**ADDENDUM NO. 03 – PORTAGE PUBLIC SCHOOLS – CENTRAL ELEMENTARY SCHOOL BP 4:
CONSTRUCTION**

ADDENDUM NO. 3 (BP4)

DATE OF ISSUANCE:	June 19, 2023
PROJECT:	Central Elementary School Bid Package 4: Construction 8422 South Westnedge Avenue Portage, MI 49002
OWNER:	Portage Public Schools
ARCHITECT'S PROJECT NO.:	21-237.10
ORIGINAL BID ISSUE DATE:	May 17, 2023

2 180 ENLARGED CAFE REFLECTED CEILING PLAN
1/4" = 1'-0"

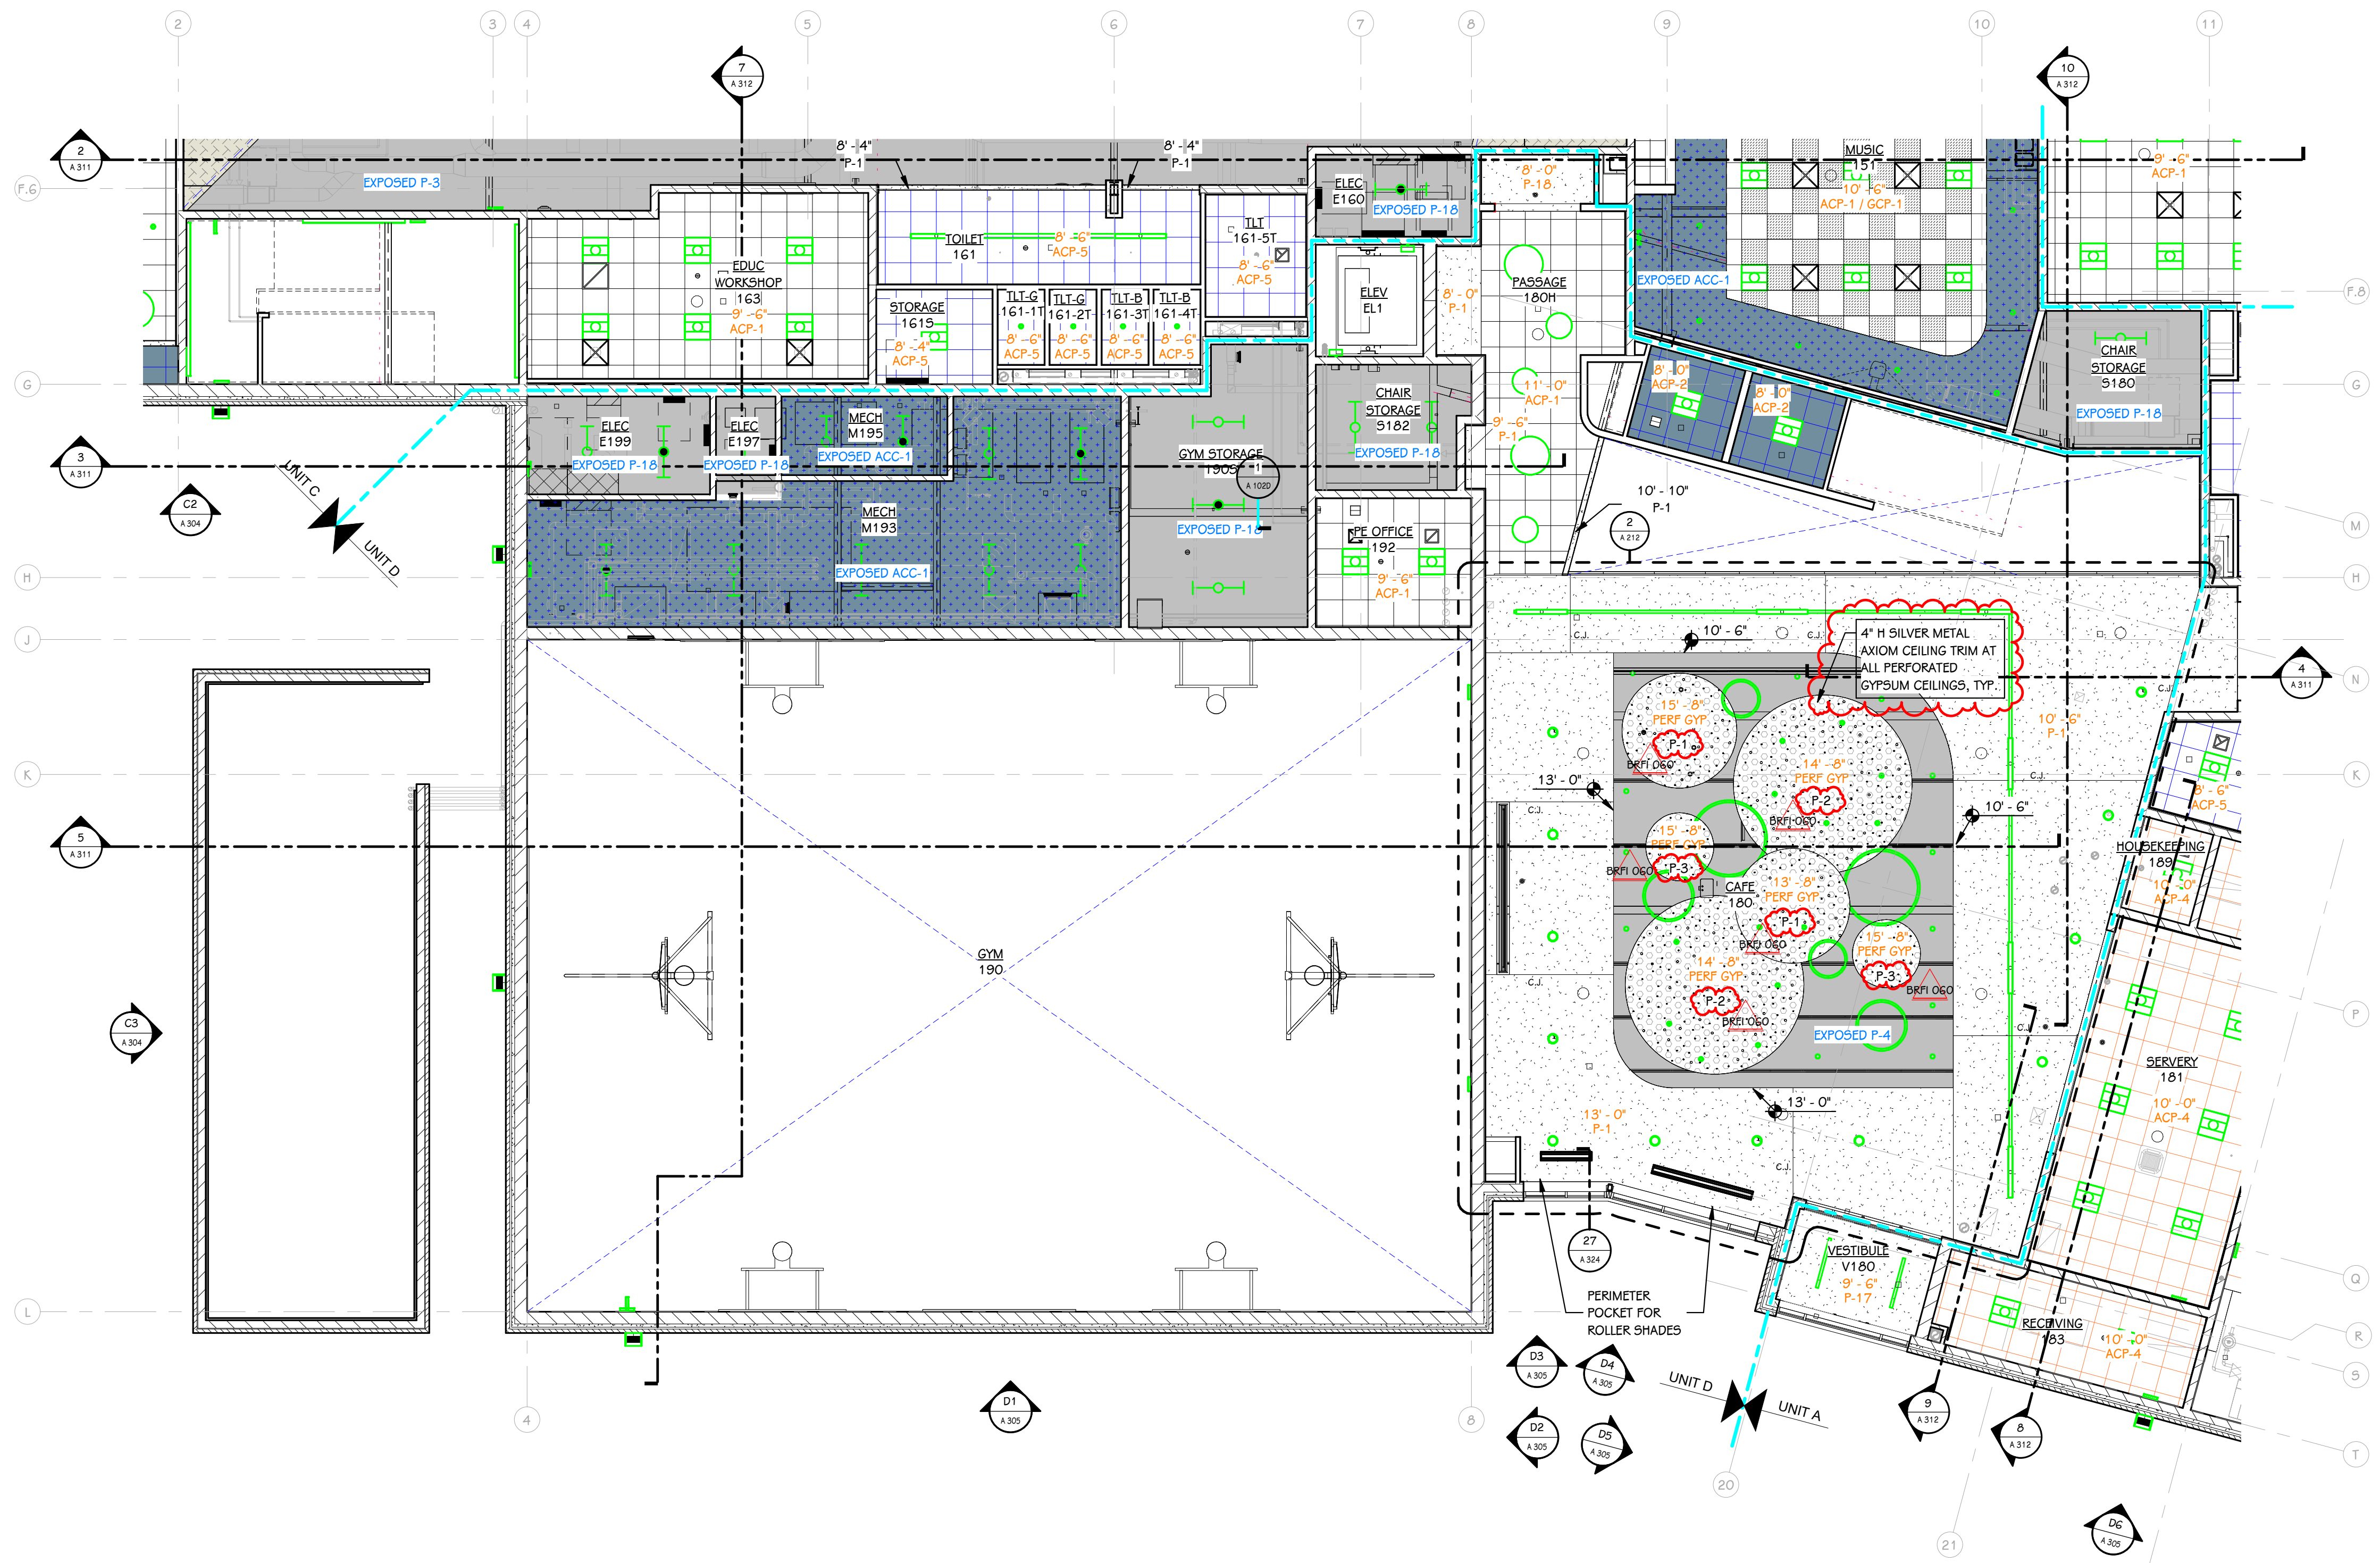
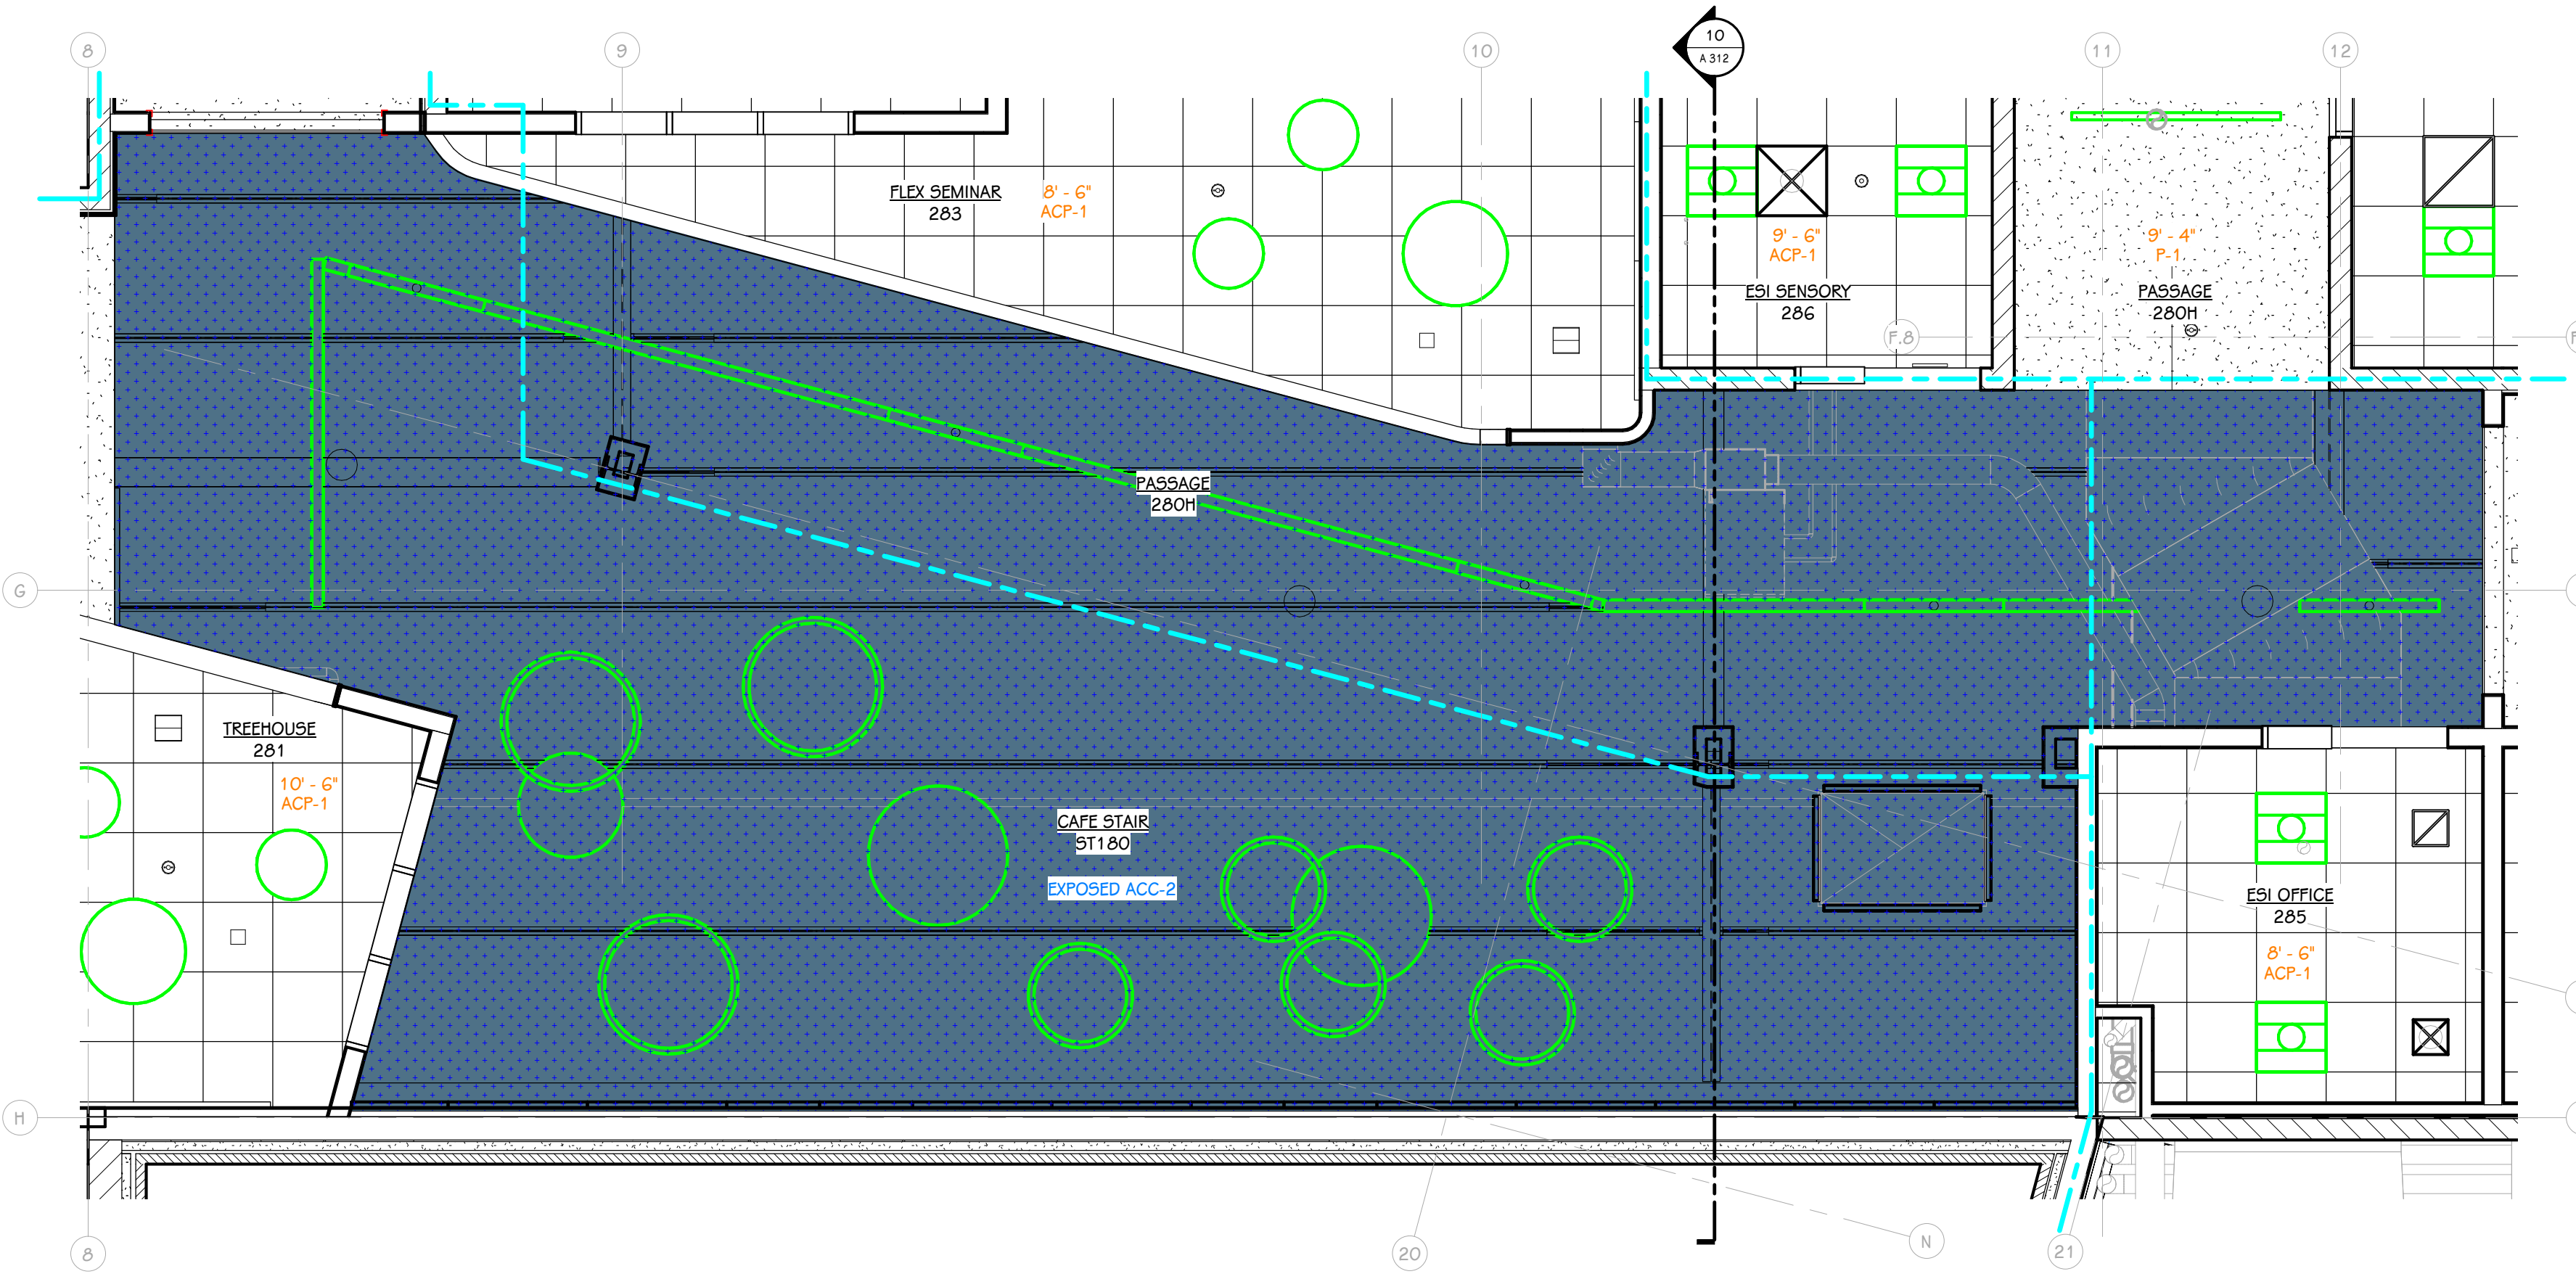
ADD 3 - BP 4 - Prebid RFI 060	Gypsum Ceiling Perimeter	On A212 they show the enlarged Café RCP. For the perforated gypsum ceiling, I am curious what the architect has in mind for the perimeter, Is there an upturn and how high? Does he want an axiom trim? I do not see a cut through detail that gives me that vital information. Bill Ritsema, Ritsema Associates, ritsemab@ritsema.com	At perforated gypsum board clouds, provide 4" height silver metal edge axiom trim. Refer to specification section 09 5113 2.6. Refer to attached updated drawings: A201D, A212. Updated paint color of perforated gypsum board clouds. - A.Carmona 06.16.2023
ADD 3 - BP 4 - Prebid RFI 062	I.T. Licensing and Integration Clarification Items	1. If sufficient portage licenses are not available on the existing controller, should a license expansion be provided? 2. Is integration required between the video surveillance and access control systems? 3. The access control hardware devices section of the bid spec specifies different hardware devices compared to drawing T441. For example, HID multiclass RFP 15 and RP40 readers are on the specs, but the bid plans specify HID Prox 5355 and 5365 readers. Other examples include differences in request to exit devices and door position switches (Bosch and Assa Abloy vs. Schlage). Should the bid specs or bid plans be followed to determine specified device types? Jamie Metcalf, Buist Electric, jmetcalf@buistelectric.com	1. FOR BIDDING PURPOSES, ASSUME THERE ARE NO SPARE LICENSES. ALL LICENSING SHOULD BE PROVIDED AS NEW. 2. NO INTEGRATION BETWEEN THE ACCESS CONTROL SYSTEM AND CAMERA SYSTEM IS DESIRED. 3. DRAWING SHEET T441 IS THE AUTHORITATIVE SOURCE. USE THE PART NUMBERS LIST THERE. THIS OVERRIDES ANY CONFLICTS ON OTHER SHEETS OR WITHIN THE SPECS.

Question from Anastasia Wojcik Owen-Ames-Kimball Co. - Kalamazoo on Thursday, Jun 15, 2023 at 02:02 PM EDT
 On A212 they show the enlarged Café RCP. For the perforated gypsum ceiling, I am curious what the architect has in mind for the perimeter, Is there an upturn and how high? Does he want an axiom trim? I do not see a cut through detail that gives me that vital information.
 Bill Ritsema, Ritsema Associates, ritsemab@ritsema.com

At perforated gypsum board clouds, provide 4" height silver metal edge axiom trim. Refer to specification section 09 5113 2.6.
